Service Bulletin

No. : MZ08-023

Model: SR7002, SR8002

Subject: Software Update Information

2. Shield Wire (1 set)

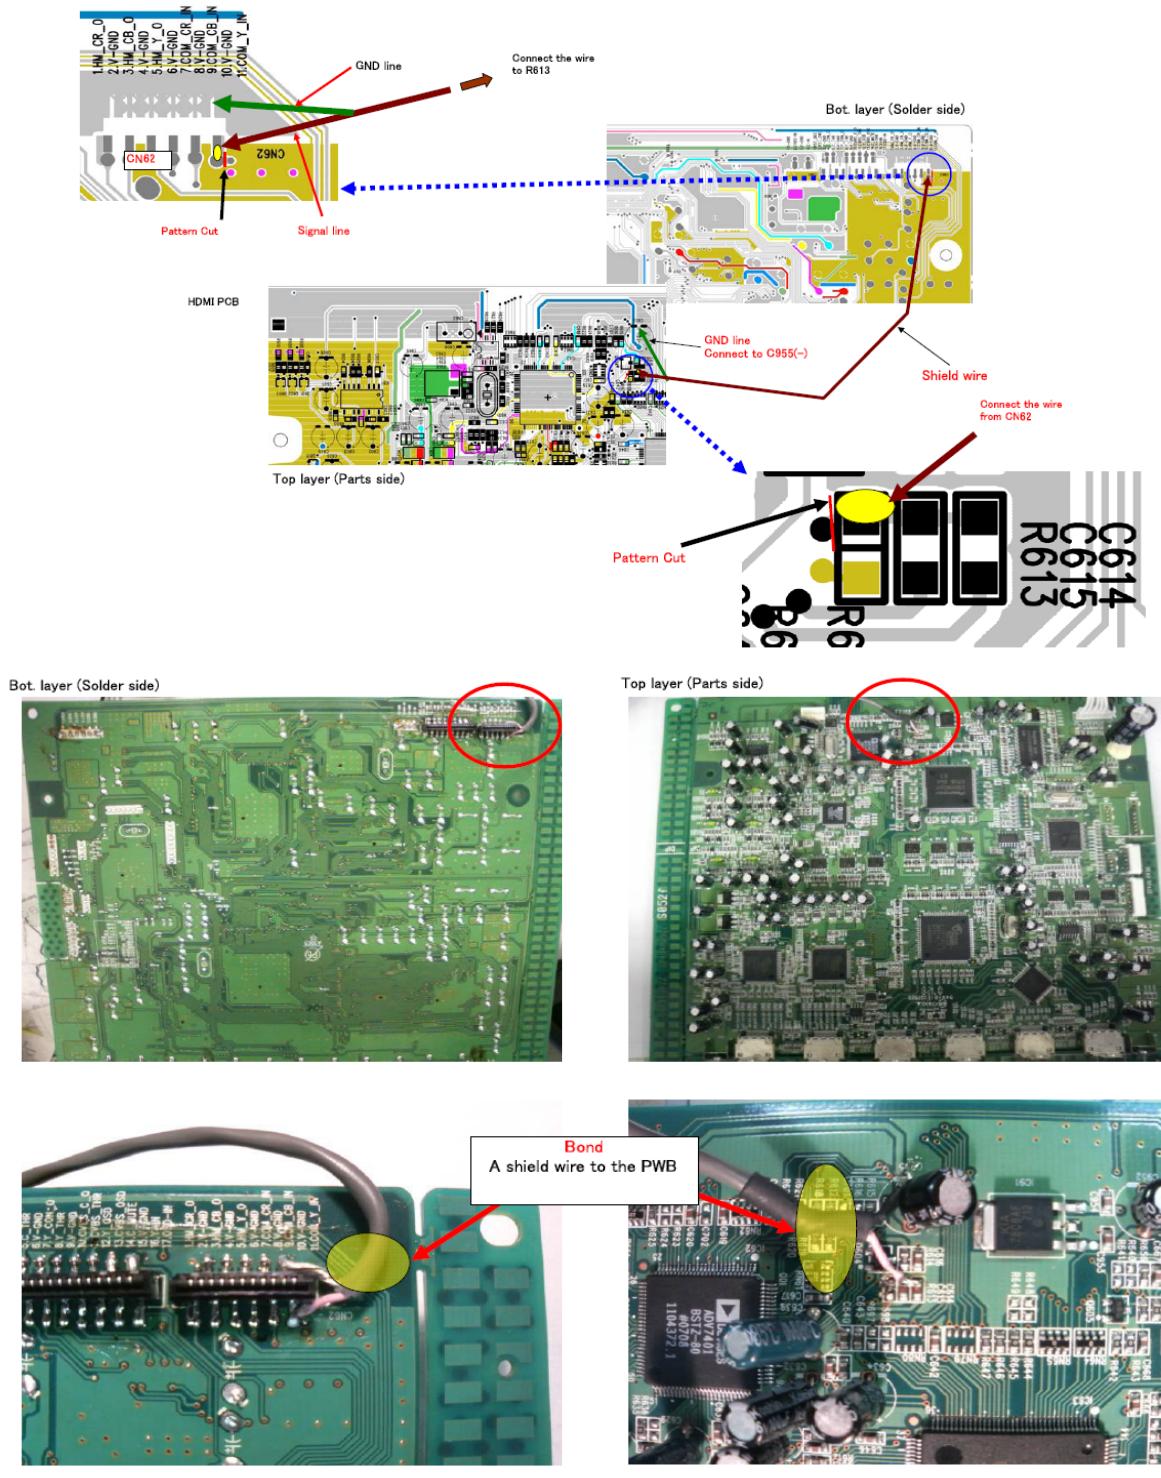
Add a shield wire to the two points where the pattern has been cut on POS. NO. 56 HDMI PWB.

1. It is connected by a shield wire from CN62 to R613 then bond to the PWB.
BOND: SONY Chemical SC608LVZ Sony Chemical Corp. Self-extinguishing adhesive or the equivalent.
2. points of pattern cut.
